Road Safety Audit Report

M-22/M-72

Michigan Department of Transportation

MDOT Job No. 204066

Figure 10 – EB M-72 at Bay Street/M-22 Conflicts (left) WSP Turn Restriction Concept (right)

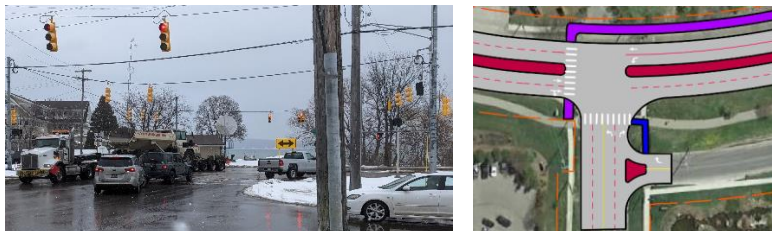
Observations: Bay Street runs parallel with M-22/M-72 within the project limits between M-72 and US-31. Bay Street intersects M-72 at a T-intersection approximately 65 feet west of M-22 where Bay Street is stop-controlled and EB M-72 traffic operates under signalized control. Turning movements between Bay Street and M-22/M-72 are complex and field observations indicate continuous vehicular conflicts. There are advanced signal heads and an advanced stop bar on EB M-72 at Bay Street approaching M-22. These advanced measures provide temporary gaps in the EB M-72 queue to allow vehicles to turn to/from Bay Street.

The most frequent turning maneuver observed at this location was from SB M-22 to EB Bay Street. Bay Street provides the first entry point to the local Traverse City street network for traffic arriving from the north. This “S” turn maneuver requires drivers to observe, perceive, and react to multiple conflict points, including the TART trail crossing of M-72. Although the advanced signal heads provide a gap to allow movements from Bay Street to M-72, vehicles are often queued EB on M-72 to turn right onto M-22/M-72.

Risk Analysis: As described in the previous section, vehicle-pedestrian crashes present the highest risk related to the complexity of turning movements at this location. Conflicting movements may result in angle crashes which tend to result in more severe outcomes; however, speeds and therefore severity risk at this location are lower due to turning movements and recurring congestion. Similarly, lower speed rear-end and sideswipe crashes are likely to occur due to the stated complexity and number of conflict points.

WSP conducted an alternatives evaluation ranging from limiting turning movements at Bay Street, to widening the M-22/M-72 median to provide indirect left-turns and eliminate left-turns at M-22/M-72 signal, to reconstructing the M-22/M-72 intersection as a roundabout. The pros of these concepts include the elimination of conflict points; however, right-of way constraints and operational impacts at this intersection and other locations on the corridor must be investigated further. An additional alternative was discussed by the RSA Team that would cul-de-sac Bay Street and provide access via a new mid-block intersection near Elmwood Avenue, which could be tied in with the signalized HAWK crossing.

At a minimum, the RSA Team suggests that left-turn restrictions to/from Bay Street at M-72 and the potential impacts be investigated. This would require a physical channelizing island and regulatory signs. The RSA Team and stakeholders also discussed concerns relative to TART trail crossing safety with a roundabout at this location. WSP operational reviews indicated a roundabout would need to have multiple lanes; therefore, additional safety measures should be considered for the TART trail crossing if a roundabout is selected as the preferred alternative.

Figure 13 – Night HAWK Crosswalk Visibility (left) NB Light Glare at HAWK (right)

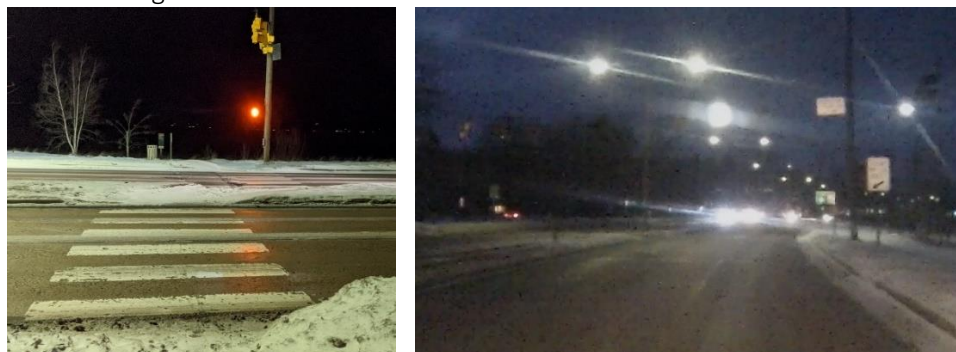
Observations: As described in the previous section, this mid-block pedestrian crossing facilitates connection for the TART trail. The crossing is fairly visible during daylight; however, at night the crossing is less conspicuous. The lighted “STOP on Red” case sign above the crosswalk does enhance nighttime recognition that something is ahead, although the message is difficult to decipher while travelling at posted speed.

Lighting is consistent along the boulevard section of the study area, and there is a light pole immediately north of the HAWK crossing that provides positive lighting onto the crosswalk. The light cast from this pole also creates a glare that inhibits visibility of the signal heads, particularly in the NB direction where the light is immediately behind the signal heads. The sidewalk approaches to the crosswalk are not as visible, especially on the darker bay side. There is a bench and lighted area on the bay side just to the north of the crossing, but this light does not cast sufficiently onto the crossing approach.

Vehicle speeds have a significant impact on the severity of injury in a vehicle-pedestrian crash. Enhancing nighttime visibility of both the crosswalk and TART trail approaches to M-22/M-72 would give drivers improved perception when a pedestrian/cyclist is present. This recognition may reduce vehicle speeds through the crosswalk and reduce driver reaction times even if the HAWK signal has not been activated. Visibility of a pedestrian/cyclist before they enter the travelled way would reduce the potential for a severe outcome crash.

1. Install additional lighting to increase nighttime visibility of pedestrians/bicyclists waiting to enter the roadway at the crosswalk approaches to M-22/M-72. This may include relocation of the existing bench/lighted area on the bay side.
2. When this roadway is reconstructed, review the location of the existing light pole immediately north of the crossing. Install lighting that casts onto the roadway and crosswalk but does not inhibit visibility of the signal heads. Signal backplates suggested in the prior section may also partially mitigate this issue.
3. Consider alternative lighting for the crosswalk including overhead crosswalk case sign options or relocating lighting at this location to the outside of the roadway to cast on the crosswalk and each approach.
